# Access Compliance Report

## Public Rights-of-Way

Intersection ID: 47124	Main Street: GOLD_WORTHY_CT	Cross Street: EMMONS_LN	Location:	N
ADA ID: C10016516279	Ramp Type: PerpDiag	Initial Pass/Fail: Fail	Overall Compliance: No	Severity Score: 25
Codes/Mitigation Info/Possible Solution		Field Measurements/Component Compliance

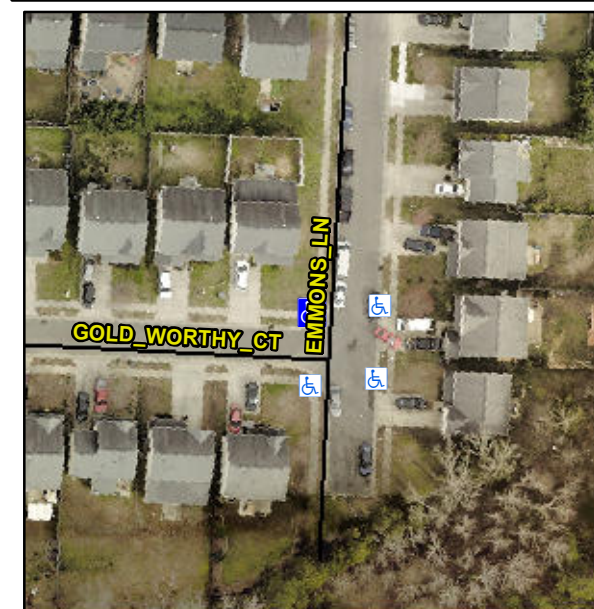
**Not Found, R304.5.3**

Compliance	Description	Data	Compliance	Description	Data
N/A	Ramp Length (in)	47.0	Yes	Ramp Slope (%)	6.7
Yes	Ramp Width (in)	48.0	No	Ramp XSlope (%)	7.9
N/A	Flare Type LT	N/A	N/A	Flare Type RT	N/A
N/A	Flare Slope LT (%)	N/A	N/A	Flare Slope RT (%)	N/A
N/A	Flare Traversable LT?	N/A	N/A	Flare Traversable RT?	N/A
N/A	Landing Length (in)	N/A	N/A	DWS Provided?	N/A
N/A	Landing Width (in)	N/A	N/A	DWS Contrast?	N/A
N/A	Landing Slope (%)	N/A	N/A	DWS Length (in)	N/A
N/A	Landing X Slope (%)	N/A	N/A	DWS Full Width?	N/A
N/A	Landing Curb? (Y/N)	N/A	N/A	DWS Offset (in)	N/A
N/A	Shared Landing?	N/A			
N/A	Gutter Ponding?	N/A	N/A	Gutter Slope (%)	N/A
N/A	Gutter Lip Ht (in)	N/A	N/A	Gutter X Slope (%)	N/A
N/A	Painted X Walk1?	No	N/A	Painted X Walk2?	No
	X Walk 1 Direction	To SW		X Walk 2 Direction	To SE
N/A	X Walk 1 Width (in)	N/A	N/A	X Walk 2 Width (in)	N/A
	X Walk 1 Slope (%)	5.8		X Walk 2 Slope (%)	1.2
	X Walk 1 X Slope (%)	4.1		X Walk 2 X Slope (%)	5.6

**Remove & Replace Curb Ramp With Two New Directional Ramps or Equivalent.**
